Dresden Nuclear Power Station, Unit 2  
Facility Operating License No. DPR-19  
NRC Docket No. 50-237

Subject: Additional Information Supporting the Request for Technical  
Specifications Change for Minimum Critical Power Ratio Safety Limit

**Attachment C**  
**Additional Information Supporting the Request for Technical Specifications Change**  
**for Minimum Critical Power Ratio Safety Limit (Non-Proprietary)**  
**Dresden Nuclear Power Station, Unit 2**

Figure 1

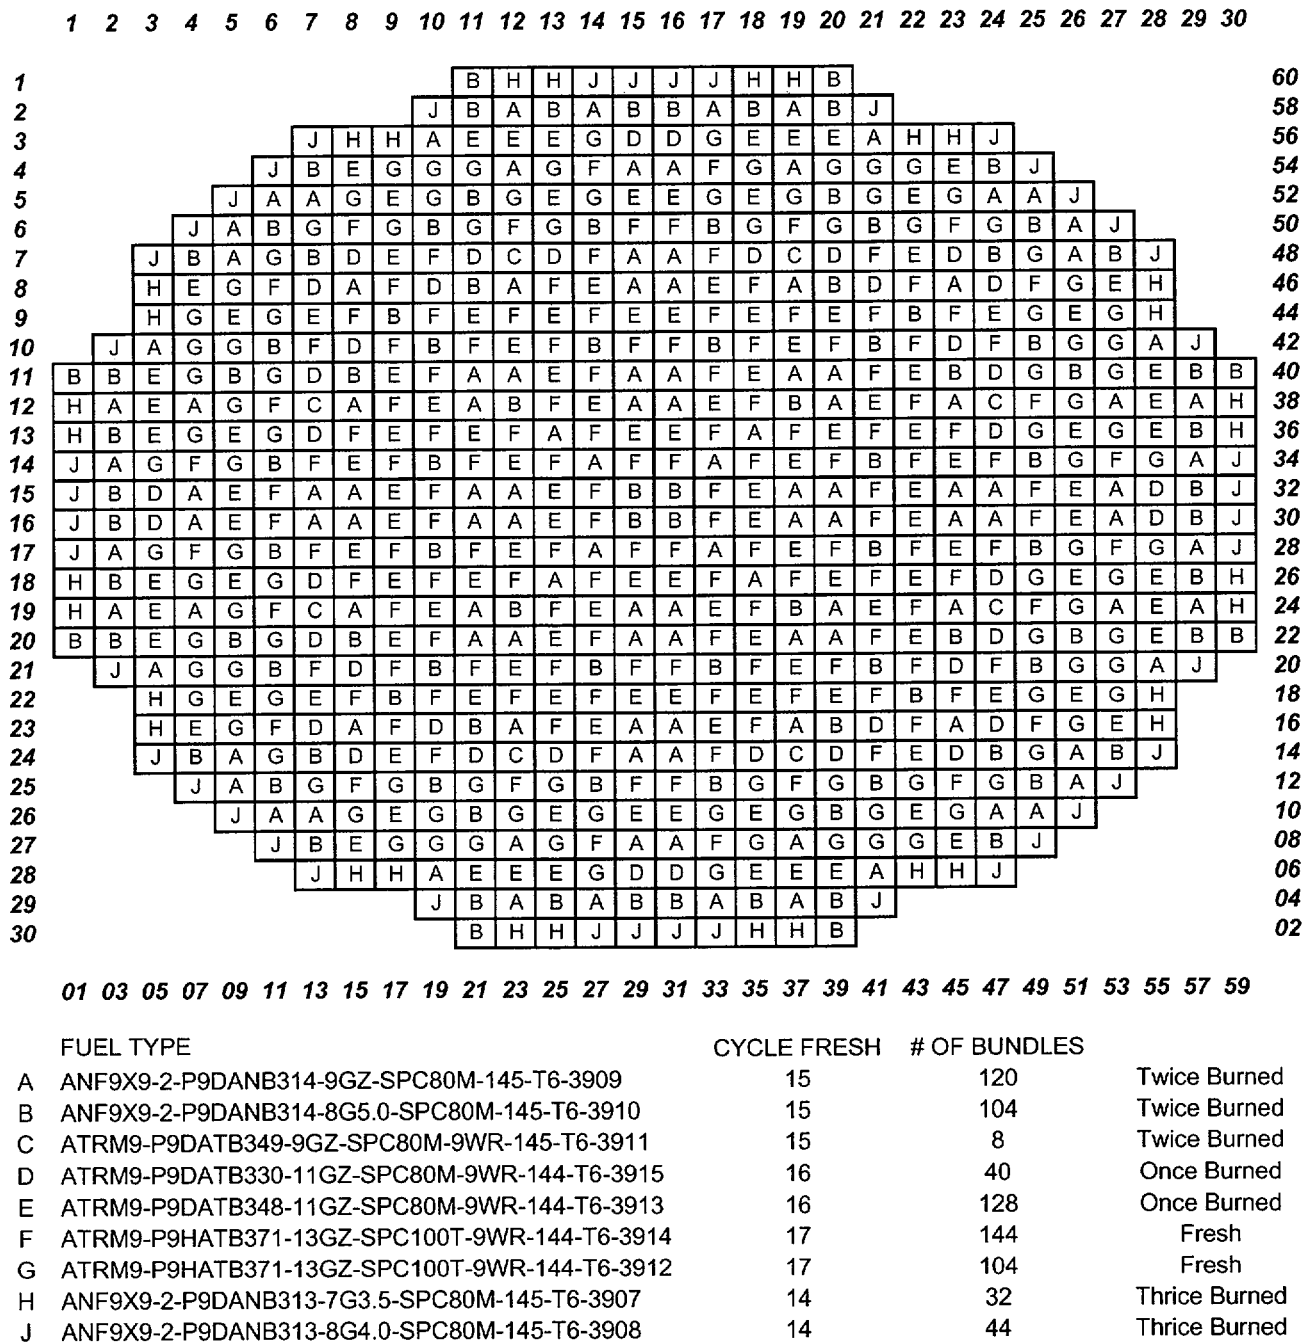
*Provide the fuel types and numbers of assemblies used in Dresden Cycle 17 and Cycle 18 operation and identify if they are fresh or irradiated fuel (once or twice burned, etc.). Also, describe the impact on the Safety Limit for the Minimum Critical Power Ratio (SLMCPR) calculation based on the fuel loading patterns for Cycle 17 and Cycle 18 mixed core.*

The fuel types, number of assemblies, cycles burned, and identification of cycle loaded are included as Figures 1 and 2 for Dresden Nuclear Power Station (DNPS), Unit 2, Cycles 17 and 18 (D2C17 and D2C18), respectively. The two loading patterns are identical to those provided in Attachment F of Reference 1. The legend is expanded to add the number of cycles burned and the cycle loaded.

In Figure 1 (D2C17), fuel types A, B, H, and J are the Framatome Advanced Nuclear Products (FANP) two water rod 9x9 design (300 assemblies total). The remaining fuel types C, D, E, F, and G are the FANP ATRIUM 9B design (424 assemblies total).
